REVIEW OF TRAC CALCULATIONS FOR CALVERT CLIFFS PTS STUDY

J.H. Jo and U.S. Rohatgi

Date Published — April 1985

LWR CODE ASSESSMENT AND APPLICATION GROUP
DEPARTMENT OF NUCLEAR ENERGY, BROOKHAVEN NATIONAL LABORATORY
UPTON, LONG ISLAND, NEW YORK 11973

Figure 9 Transient 11: Full Steam Line Break with Stuck Open MSIVS
Steamline Pressure

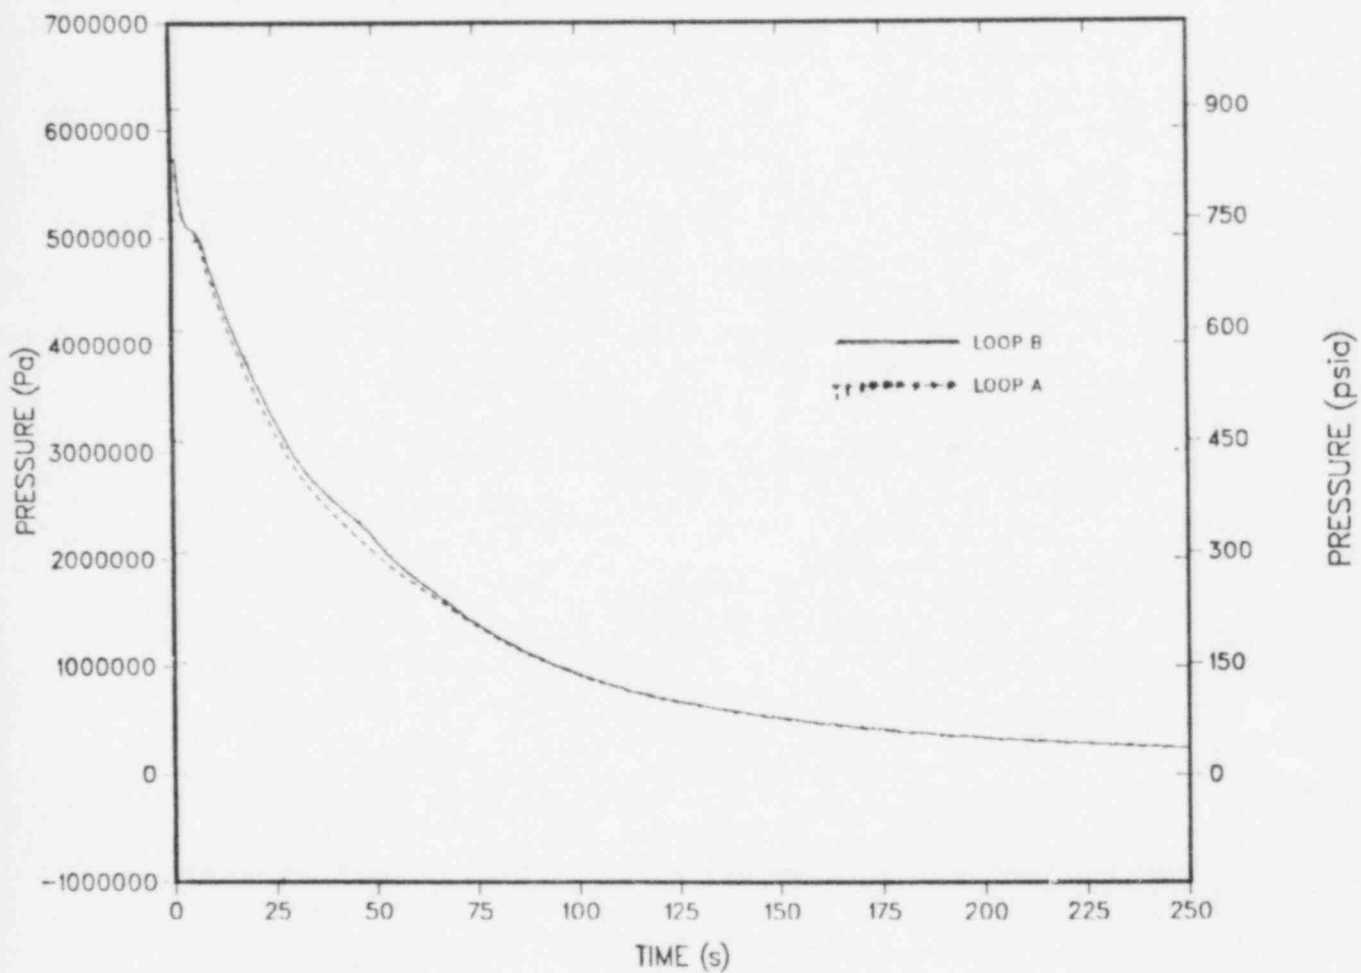
The secondary side pressure of the SGs decreased approximately along the saturation pressure of the system temperature (Figure 9). The system reached the PORV set point earlier than Transient 2 despite similar temperature behavior. This may be due to the longer HPI period. Both steam generators were expected to be empty at 7800 seconds based on the liquid mass in the SGs at 3000 seconds.

Figure 12 Calvert Cliffs Unit 1 - PTS Transient 7A:
Reactor Vessel Downcomer

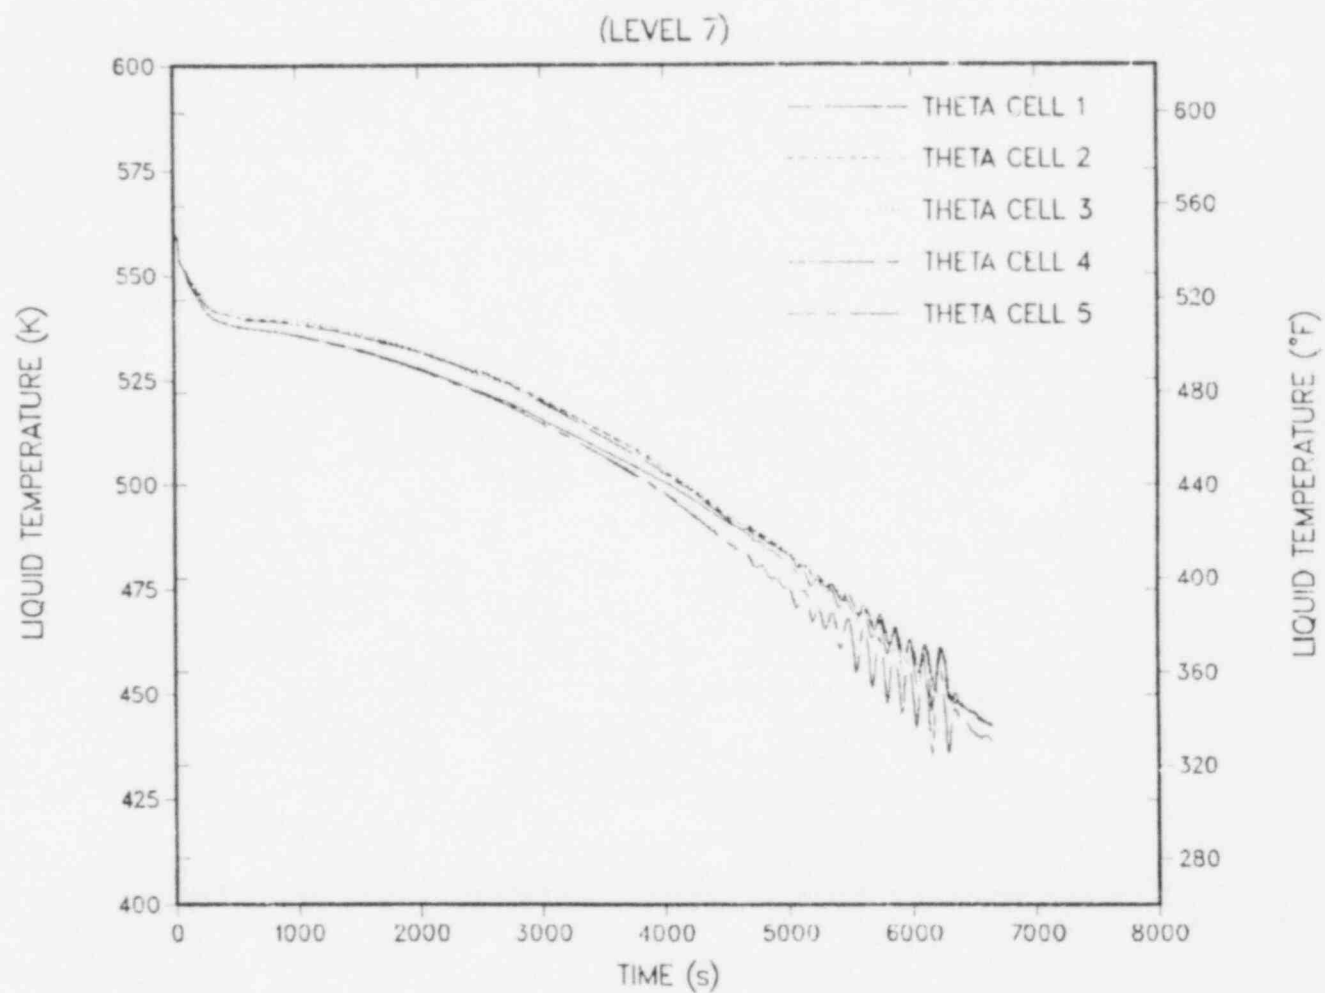
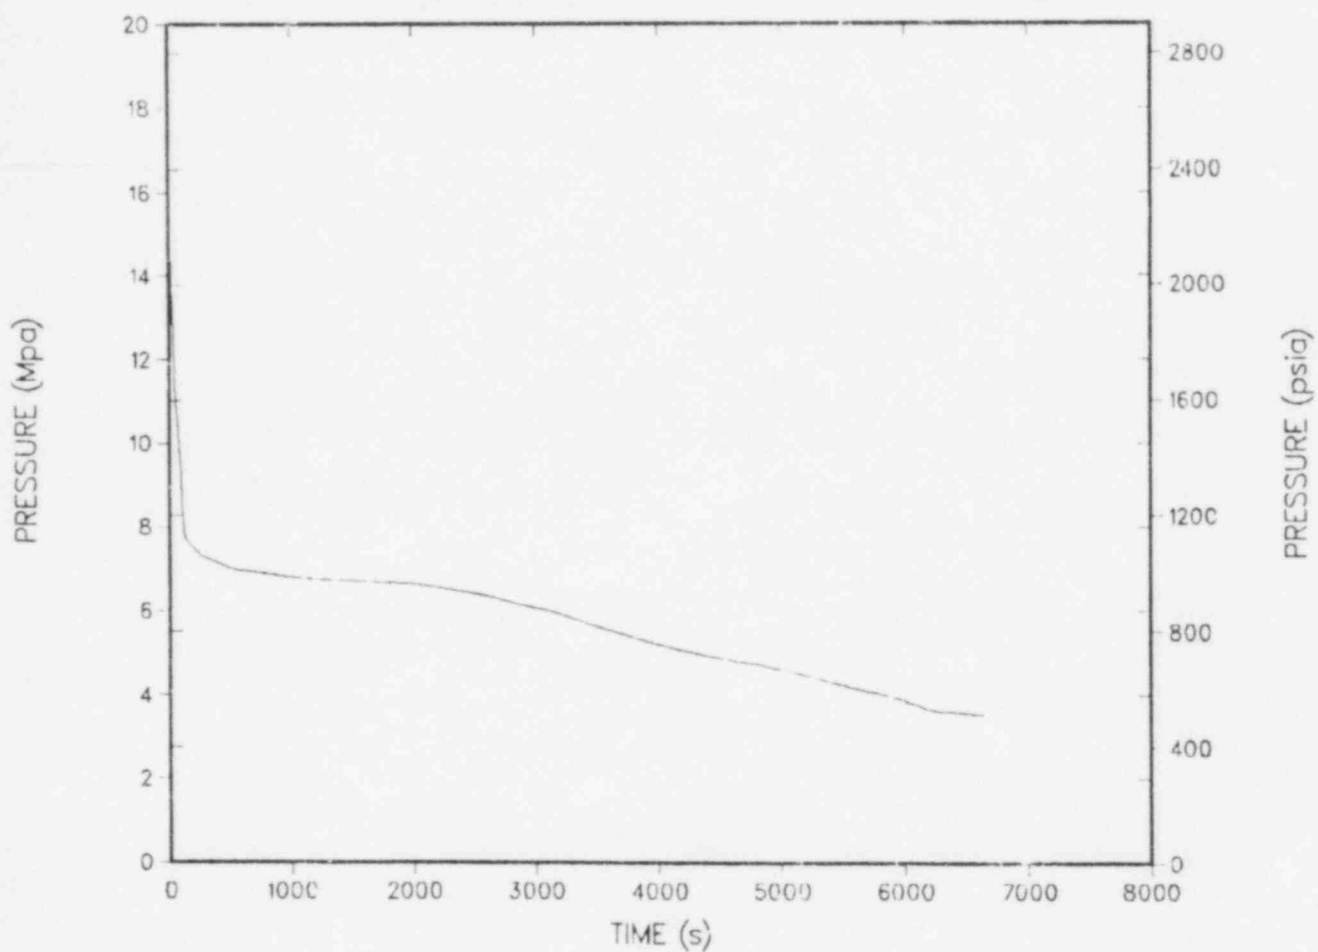
This transient was initiated by a small break (0.02 ft^2) in a hot leg. Figures 12 and 13 show the calculated primary temperature and pressure, respectively. At the initiation of the break, the primary pressure would start

In summary, the sequence of events of the calculations generally appeared to follow the expected trend except the SG pressure. There was insufficient information in the handout to check the timing of the events or the magnitude of the temperature and pressure change.
